C74-6502 PCB Patch Guide (v1.0 Boards)

The following patches were applied to the C74-6502 V1.0 prototype boards during debugging. Patches are divided into three categories:

Card B — Bottom

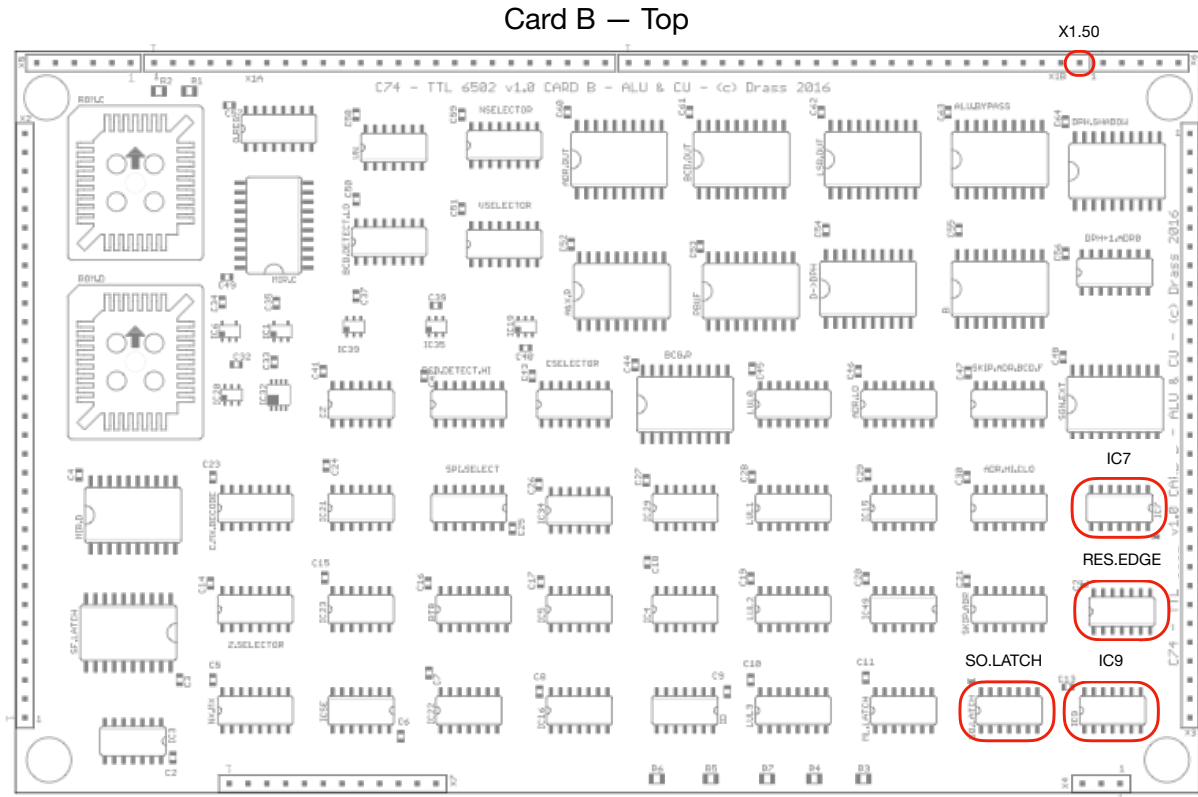
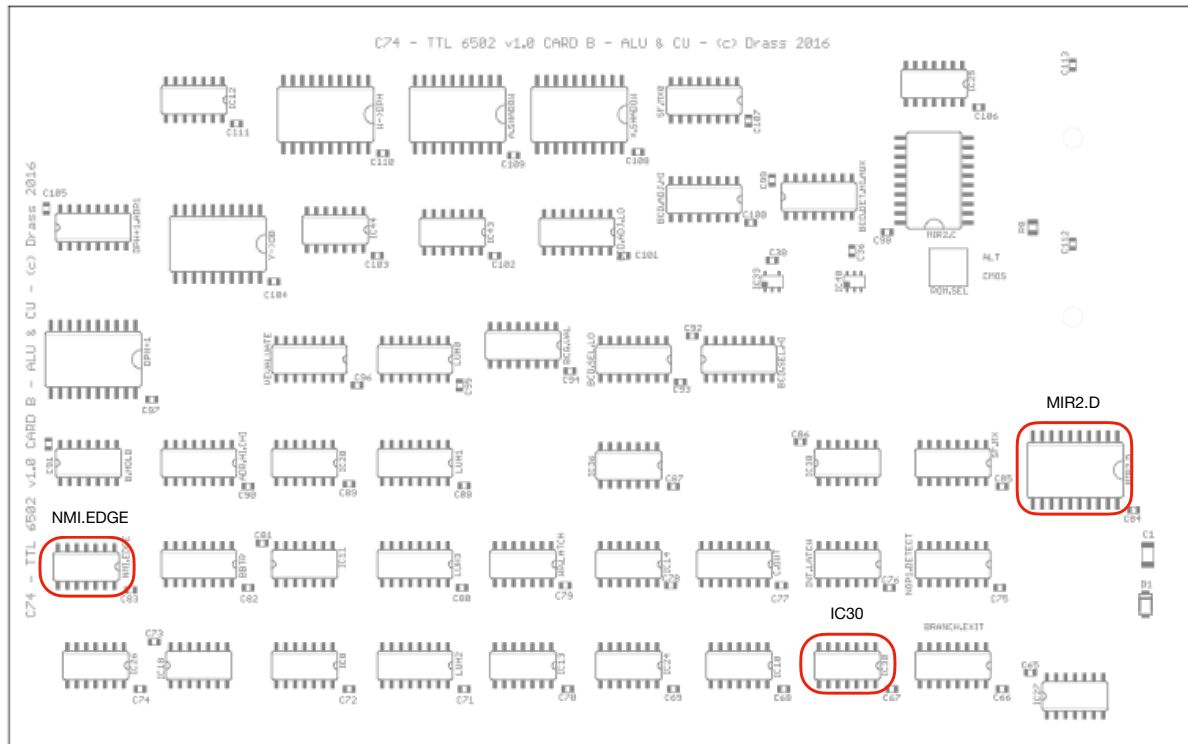
Description: This patch fixes a bug where the CPU will loose an IRQ if an NMI happens to arrive just as the IRQ vector is being fetched by the CPU.

- Card B: X1.50 → SO.LATCH.10 (LIFT)
- Card B: IC9.8 → SO.LATCH.11 (LIFT) [IC9 = silkscreen IC40]
- Card B: SO.LATCH.14 → SO.LATCH.13 (LIFT)
- Card B: RES.EDGE.6 (LIFT) → RES.EDGE.11 (LIFT)

- Card B: SO.LATCH.8 → IC30.13 (LIFT) [IC30 = silkscreen IC61]
- Card B: MIR2.D.11 → IC30.12 (LIFT)
- Card B: IC30.11 → NMI.3 (LIFT)
